DESIGN QP	DRAWN BY JC	DART AEROSPACE LTD HAWKESBURY, ONTARIO, CANADA	
CHECKED QP	APPROVED [Signature]	DRAWING NO. D3592	REV. B SHEET 1 OF 1
DATE 07.05.31		TITLE PLATE	SCALE 1:1
A	07.01.15	NEW ISSUE	
B	07.05.31	TOOLING HOLES ADDED

### D3592-1 PLATE

DRAWING NO. D3592	TITLE PLATE	REV. B	DART AEROSPACE LTD ENGINEERING ORDER		D.E.O. NO. D3592-B-1	SHEET NO. SHEET 1 OF 1	SCALE NTS
DRAWN AJS	CHECKED		MFG. APPR.	APPROVED	DE APPR.		
DATE 08.09.11	DATE 08.09.11	DATE 08.09.11	DATE 08.09.11	DATE 08.09.11	DATE 08.09.11

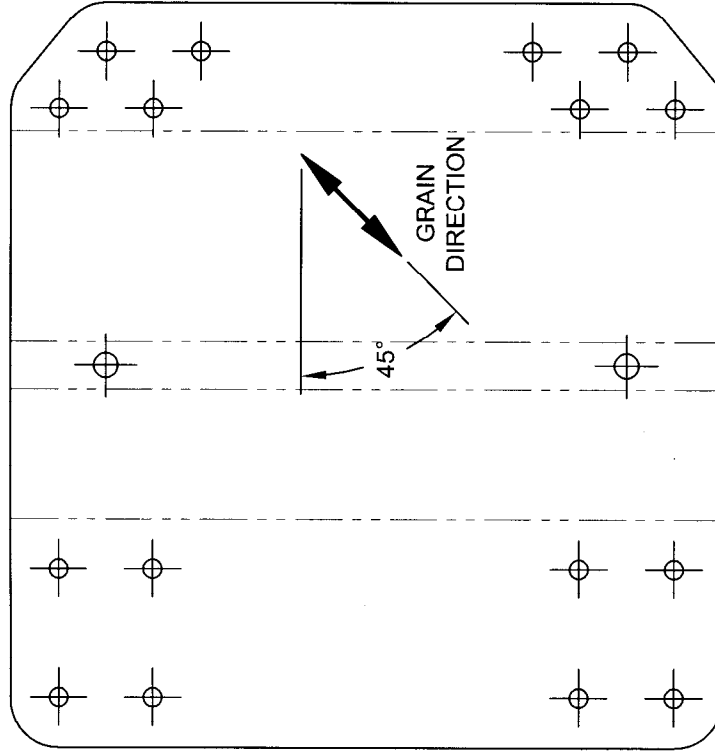
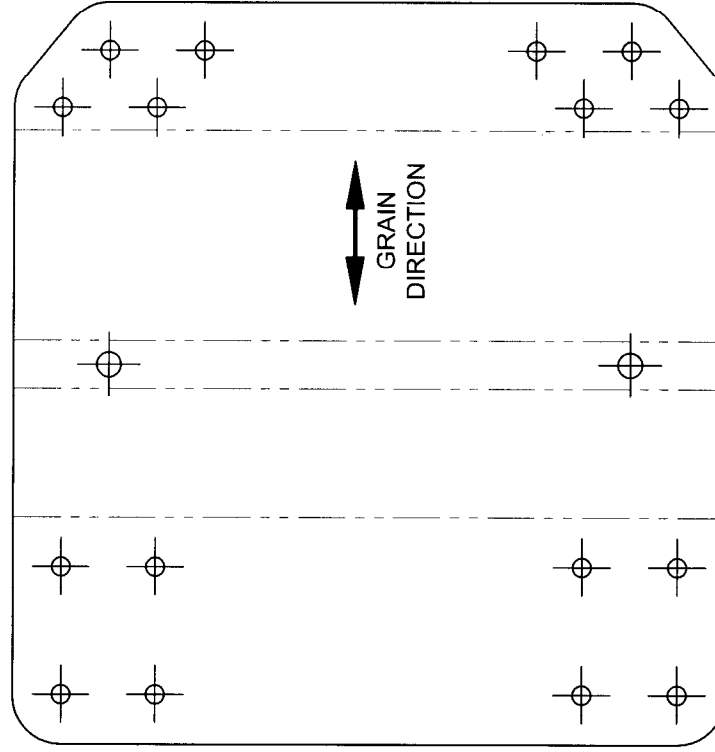
MODIFY GRAIN DIRECTION AS SHOWN BELOW TO PREVENT CRACKING WHEN WELDING AT ASSEMBLY (SEE CAR 08-026).
